### **Report on Civil Engineering Infrastructure**

### **Proposed Development of a New Machinery Yard and Regional Salt Barn, Jigginstown, Newhall, Naas, Co Kildare**

Title: **STAGE 1 ROAD SAFETY AUDIT**

**Proposed Machinery Yard, Naas, Co. Kildare.**

### 3.2 Problem

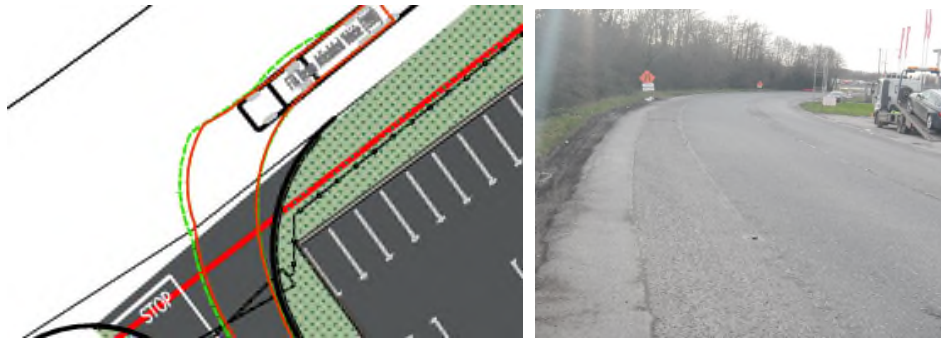
There is a narrow hard shoulder on the public road. It is unclear what facilities, if any, are being provided to terminate the hard shoulder on approach to the junction. There is a risk that drivers wishing to turn right into the facility will use the hard shoulder to decelerate. This may lead to following drivers overtaking slow moving vehicles. The overtaking vehicles may not be visible to drivers exiting the site and this could lead to rear-end or side-swipe collisions.

It is recommended that as the design develops that the hard shoulder is taken into account and ensure that it is not used as a deceleration lane.

3.2	Y	Y	The M7 Interchange Upgrade will be completed before the proposed development becomes operational. The existing M7 Slip Road will become a lightly trafficked local road and the risk of this conflict will reduce accordingly. However, measures to discourage the use of the hard shoulder as a deceleration land will be integrated into the detailed design.

### 3.4 Problem

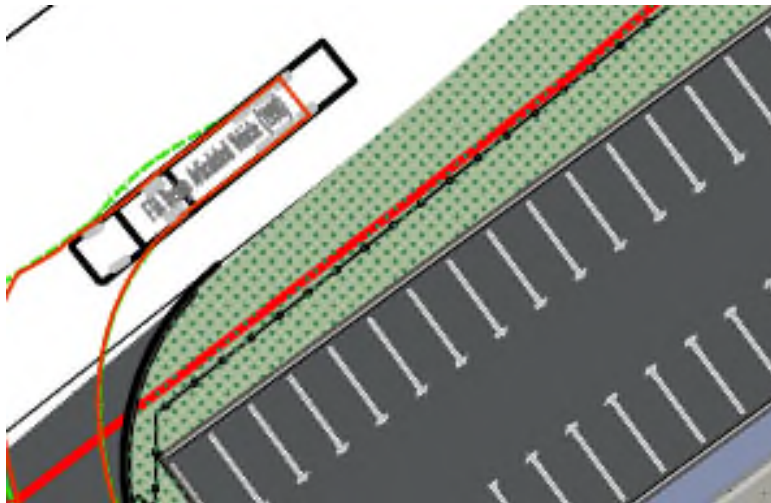
It is unclear what type of security fencing is proposed along the road boundary. Fences with rails (like the existing timber post and rail fence) could lead to increased injury severity for vehicle occupants who collide with the fence should the rails penetrate the windshield, floor or engine block of the vehicle.

It is recommended that rail-less passively safe fencing is provided along the road boundary where the fence is within the Clear Zone.

3.4	Y	Y	A risk assessment will be carried out for the road edge in accordance with TII Guidelines. Where the roadside boundary is within the clear zone and not passively safe, a safety barrier will be incorporated into the detailed design.

### 3.5 Problem

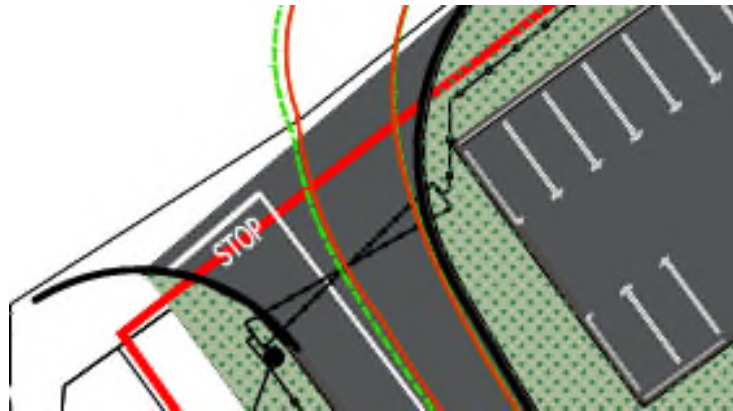
The proposed development is shown to be gated at the access point. It is unclear if there will be a need for drivers to wait for the gates to be opened and if so where they will park. Vehicles parked partially on the running lane may lead to collisions with through traffic.

It is recommended that the gates be set back far enough so that a typical vehicle is completely off the carriageway while the driver is waiting for the gates to be opened.

3.5	Y	Y	The gate will be open at all times when the depot is operational. The gate had been set-back to 10m from the road edge to ensure adequate space is available for staff to turn-off the public road and park while opening the gate.	
3.6	Y	Y

3.6 Problem

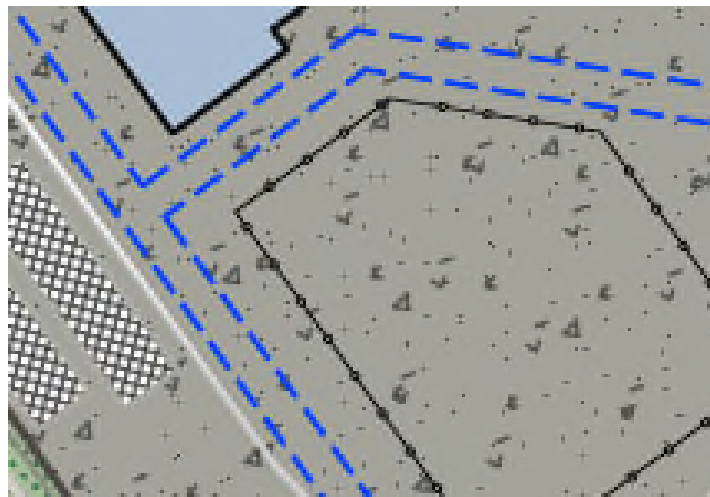
The pedestrian routes through the yard are shown on the drawing. It is unclear if these routes are to be delineated with road markings and signage. Without adequate delineation pedestrians may stray from the prescribed routes and may put themselves at increased risk of being struck by moving machinery.

It is recommended that at the detailed design stage that pedestrian routes are clearly delineated.
